Staff Report
Site Plan Review Application
Mixed-Use Development on North Shore LU 2022 02 (Phase 1)
August 31, 2022

1. **PROPOSAL.** The Planning Commission is being asked to review and render a decision on an application for site plan review for Phase 1 of construction of a new three-story building that will contain 3,600 square feet of commercial space on the ground floor and residential units on floors two and three. Per the applicant's narrative letter, submitted for the LU 2021-11, the residential units will be a combination of 1–3-bedroom units and there will be 10 units in total. The proposal will include a 22 off-street parking spaces. All off-street parking will be located behind the new building and take access from North Pioneer Street. Landscaping features will be placed along the edge of the property line abutting the right-of-way on North Pioneer Street and North Shore Drive.

Image 1. North Pioneer Street Section as seen in the Downtown Master Plan

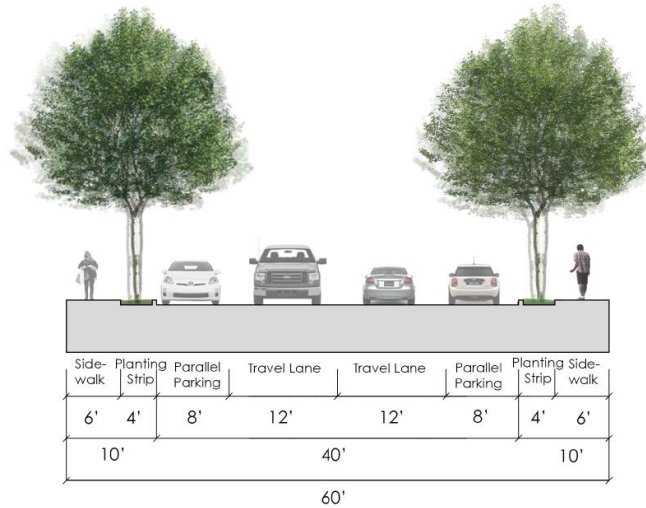
In addressing pedestrian and vehicular safety, the inclusion of urban street improvements along the frontage of North Pioneer Street (image 1), adjacent to the site, will facilitate the movement of pedestrians from the right-of-way, across the sidewalk and to the proposed mixed-use development. The inclusion of on-street parking adjacent to the site will free up off-street parking spaces designated for residents and employees of the mixed-use development. Additionally, on-street parking is a central theme of the Lowell Downtown Master Plan that creates active streets and encourages the built form to interact with pedestrians. Further, on-street parking encourages other by-passing vehicles to reduce driving speed because drivers are wary of traffic and adjacent users.

Staff Response: As seen in Images 1 and 2, above, the sidewalk design for North Pioneer Street is 6' in width.

Condition of Approval #1: Applicant shall submit plans for review and approval by the City Administrator or their designee for the construction of urban street improvements along the frontage of North Pioneer Street, consistent with the Lowell Downtown Master Plan to include a 6’ sidewalk, 4’ planting strip, 8’ parallel parking stall, and street trees to facilitate the movement of pedestrians from North Shore to Phase 1 of the proposed development. The plans shall be approved, before the issuance of building permits.

Image 2. North Pioneer Street section from Lowell Downtown Master Plan.

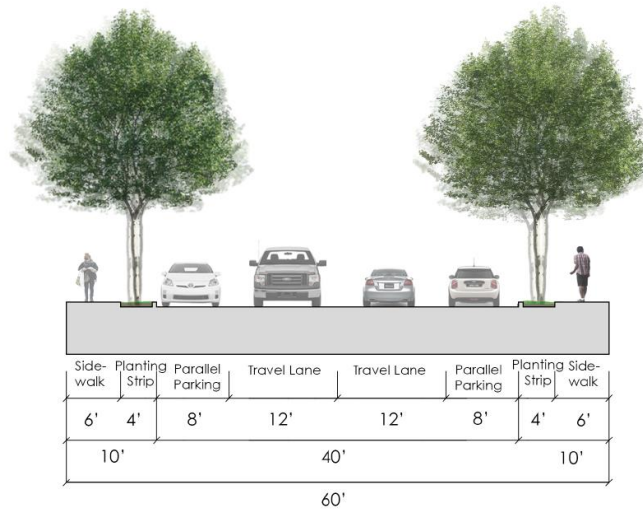
- The applicant is already proposing frontage improvements along North Pioneer Street. The details of the improvements are not clear to staff as the site plan just shows a general landscaping detail, new asphalt, a sidewalk of uncertain width, and trees/brushes. Since improvements are already being made to this section of North Pioneer, they should conform to the adopted standards of the Downtown Master Plan for that specific section of North Pioneer Street. The Lowell Development Code, in

Image 3. North Pioneer Street details as adopted in the Lowell Downtown Master Plan.

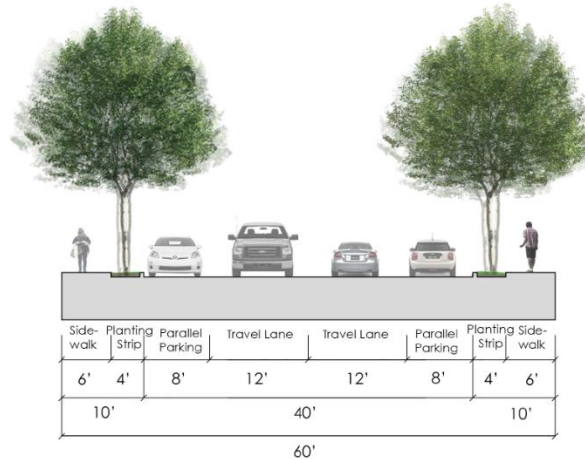
The specific improvements required for this portion of North Pioneer Street are shown in Images 1-3 of this report, which are the adopted street section for North Pioneer Street. Urban street improvements, consistent with the Lowell Downtown Master Plan and as seen in images 1-3 in this report has been appropriately conditioned as **Condition of Approval #1**.

1 AS-003 Architectural Site Plan
SCALE: 1" = 30'

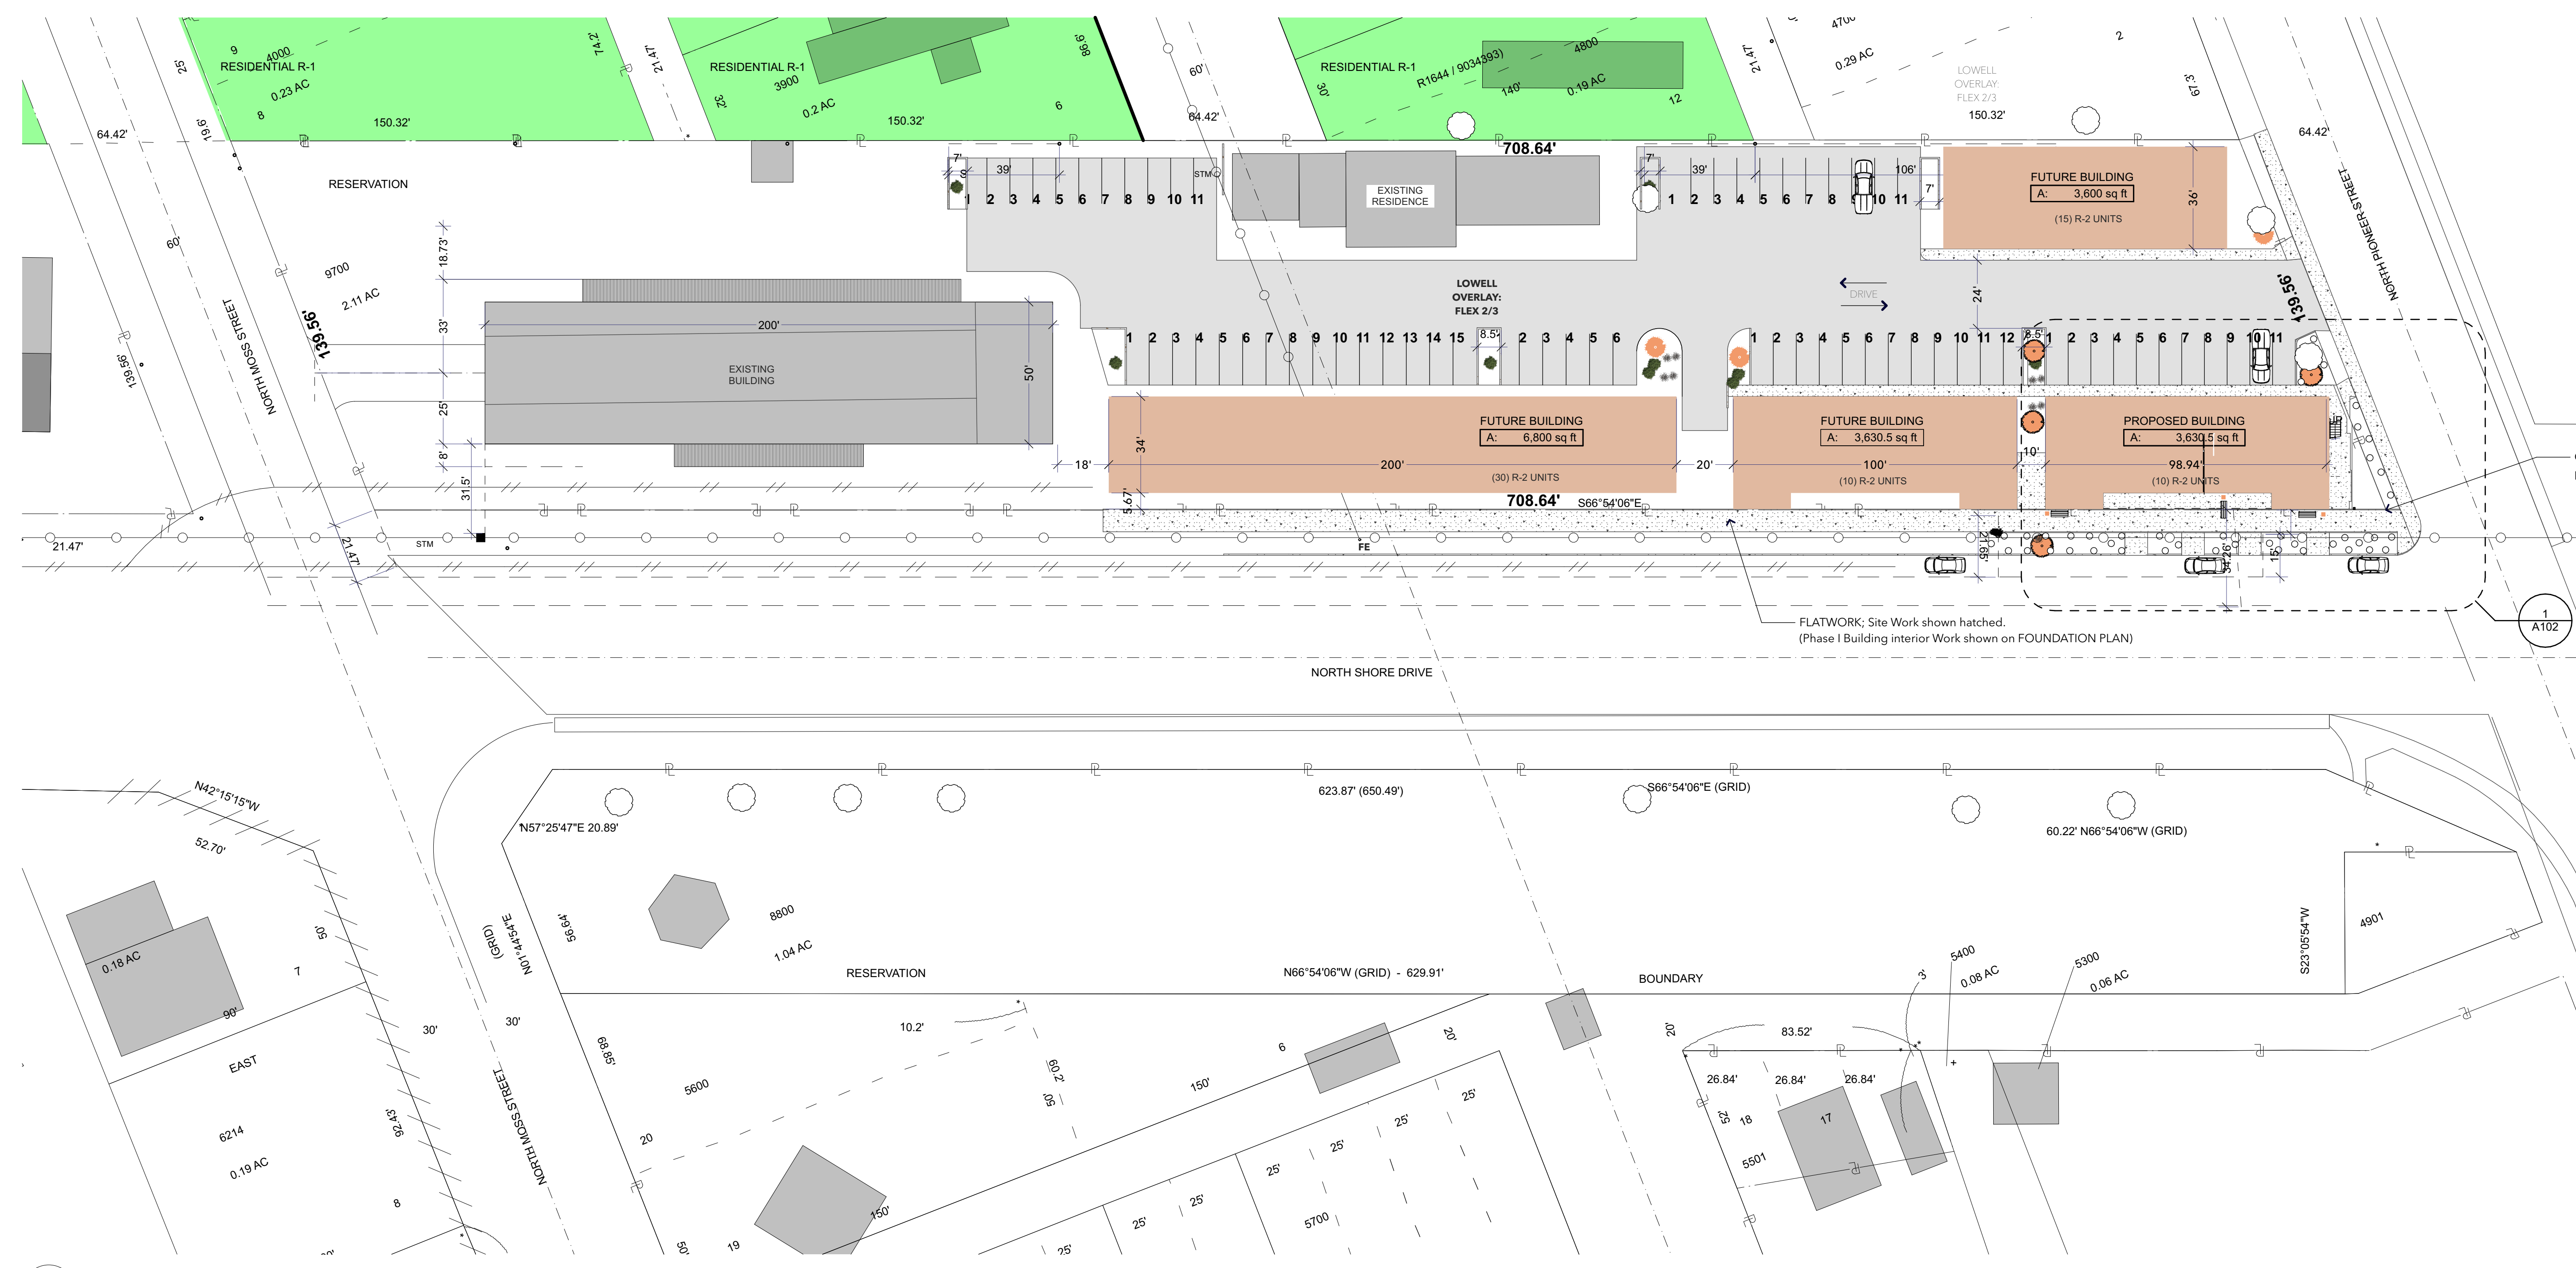
- Landscape plan
 - There appear to be two site plans in the record submitted by the applicant. Both site plans are labeled "AS-003," but contains different dates. One site plan is dated 7/27/2022 and the other 11/23/2021. Staff are unsure what site plan is the operating and effective site plan.

- Staff are unsure of the landscape improvements are proposed along the frontage of North Shore Drive. Sheet AS-003 shows three tree figures spaced apart, but staff are unsure how this correlate to Sheet L-2.

- The applicant submitted two site plans (labeled AS-003 and dated 11/23/2021 and 7/27/2022) that show top elevations of the catch basins, a stormwater line, elevation of the southeastern sidewalk and a 12" PVC. Sheet AS-003 does not contain any technical grading or drainage

Staff Response: Presently, the site is vacant and is not connected to City services. The applicant will tap into and extend the existing water and sewer mains located behind the property in First Street. See Sheet AS-003 for connection points. The applicant has submitted a basic site plan that shows an existing storm sewer tie in located in First Street where the applicant is proposing to tie into new water and sanitary sewer connections. A possible storm water tie in is shown on the site plan, with on the tie in leading out towards the right-of-way on North Shore Drive. Proposed catch basin locations have also been noted on the site plan.

Staff Response: As seen on Sheet AS-003, the parking lot contains one curbed landscape island between parking stall # 9 and #11. The landscape island appears to contain a tree feature. The code standard is for trees to be placed at the ends of parking rows to facilitate movement of traffic and to break large areas of parking surface. The proposal is short one landscape island, with a tree, at the end of the parking spaces. A landscape island, with a tree, will need to be placed at the end of the proposed parking spaces for Phase 1. This will be a condition of approval.

Staff Response: As seen on Sheet AS-003, the applicant is proposing a recycling enclosure at the far western side of Phase 1 see “recycle enclosure” on site plan. The plans do not show how the recycling enclosure will be screened from public view and landscaped. This will be a condition of approval.

Sidewalk to Enter the
 Building - Culver under
 to Existing BIO-Swale

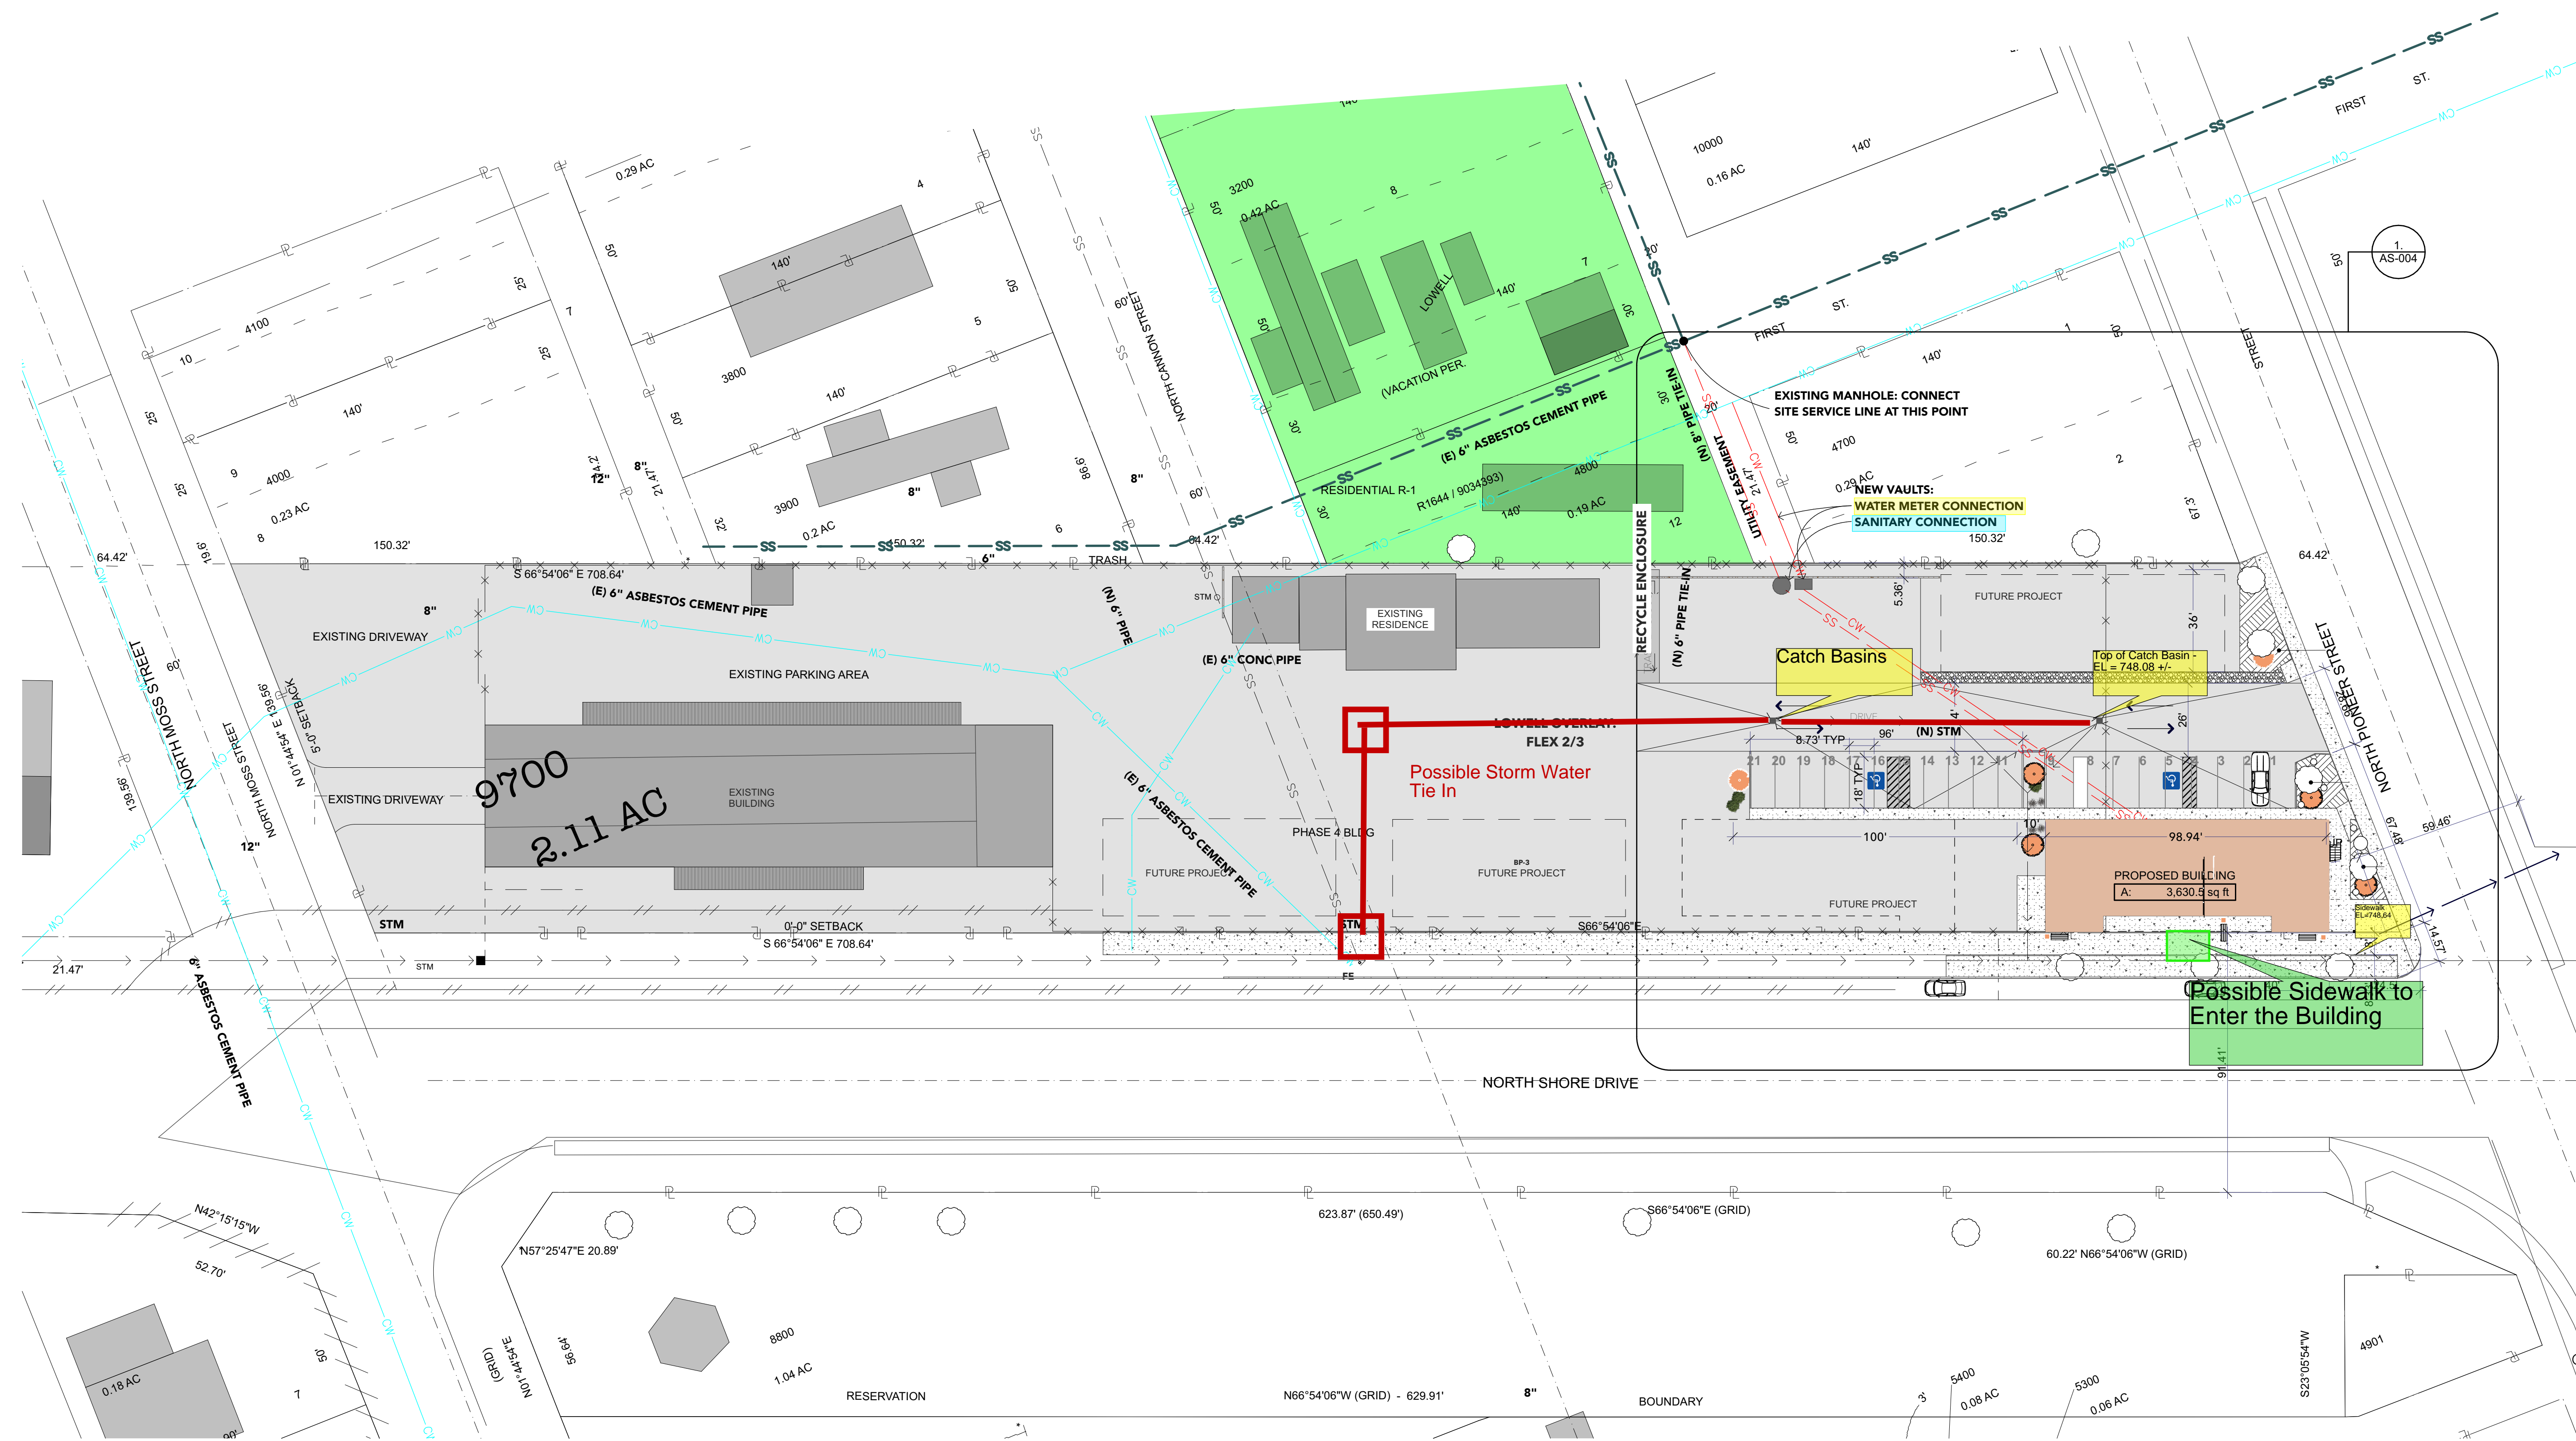
The applicant will be required to address drainage of the bioswale located between the curb of North Shore and the property line (see applicant's illustrative site plan Sheet AS-0003, "culvert under to existing BIO swale." Lane County will require this area to be addressed, in terms of drainage, as part of a Lane County Facility permit.

Low Screen Landscape (L-2)

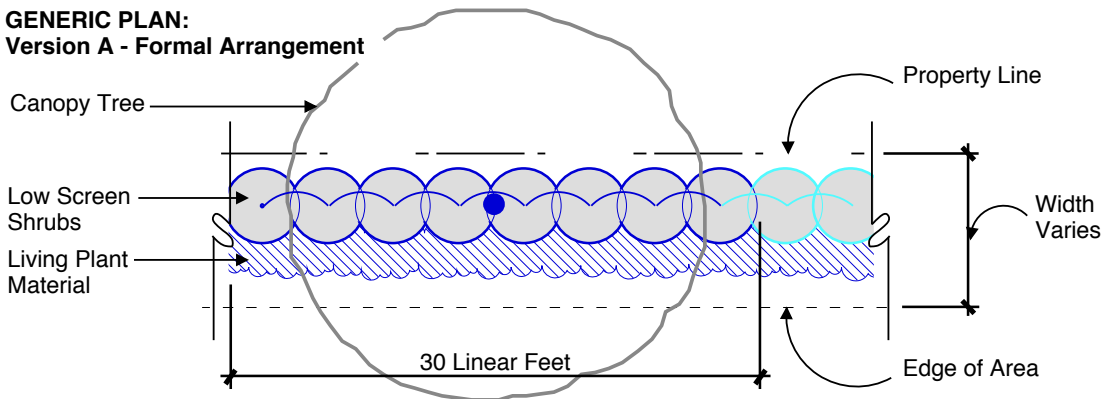
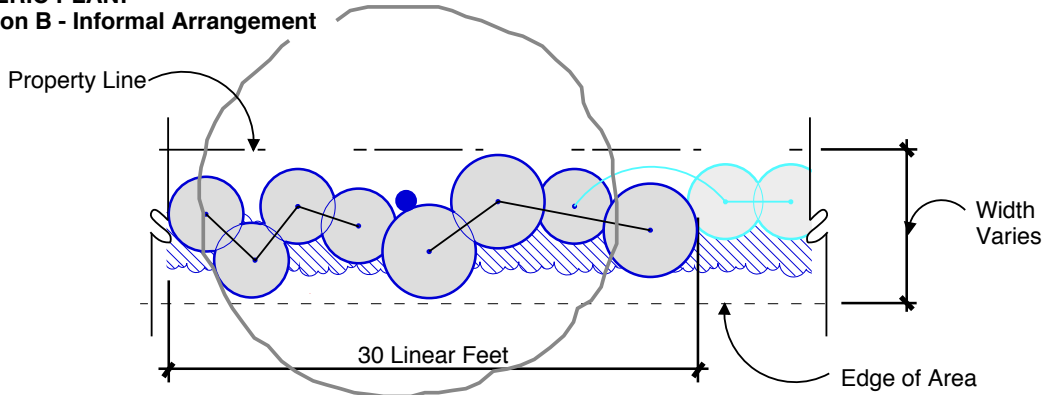
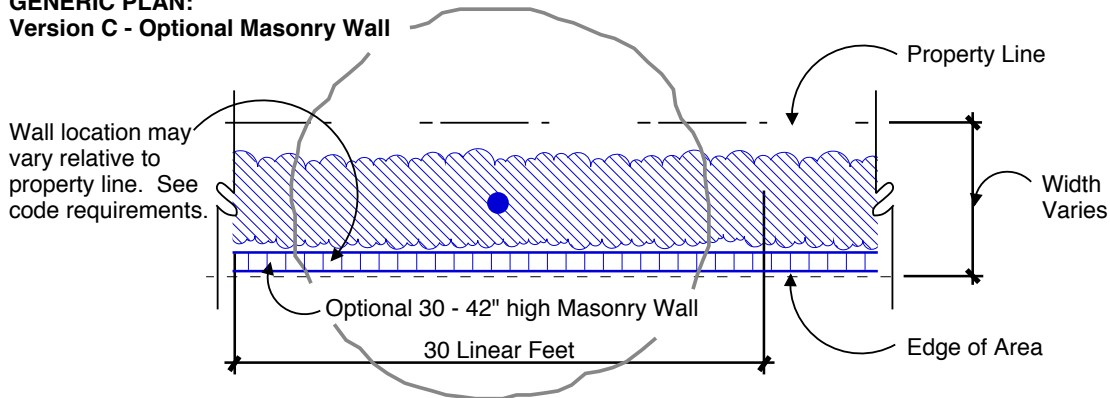
- The landscape plan submitted by the applicant is Sheet L-2. Sheet L-2 shows three generic plans as "Version A – formal arrangement," "Version B – informal arrangement," and "Version C – optional masonry wall." Staff are unsure which version is proposed for the site and where it will be located on the site.

Staff Response: As seen on Sheet AS-003 and the Low Screen Landscape Sheet (L-2), the applicant is proposing landscaping throughout the site, but staff are uncertain as which landscaping versions are proposed for which areas of the site. Decorative design elements are not proposed.

Staff Response: The applicant submitted a basic landscape plan as seen on Sheet AS-003 and L-2. It is unclear as to what landscape features as seen on Sheet L-2 are proposed for which areas of the site. Trees exceeding 10 inches in diameter, plantings and special site features are not clearly shown. The applicant has not indicated which items are proposed or removal and those intended to be preserved. Staff are unable to clearly find this criterion met. Planning Commission consideration of this requirement is requested. If Planning Commission finds the landscape plans acceptable and meeting the criteria then it can delegate a final landscape plan to be submitted,
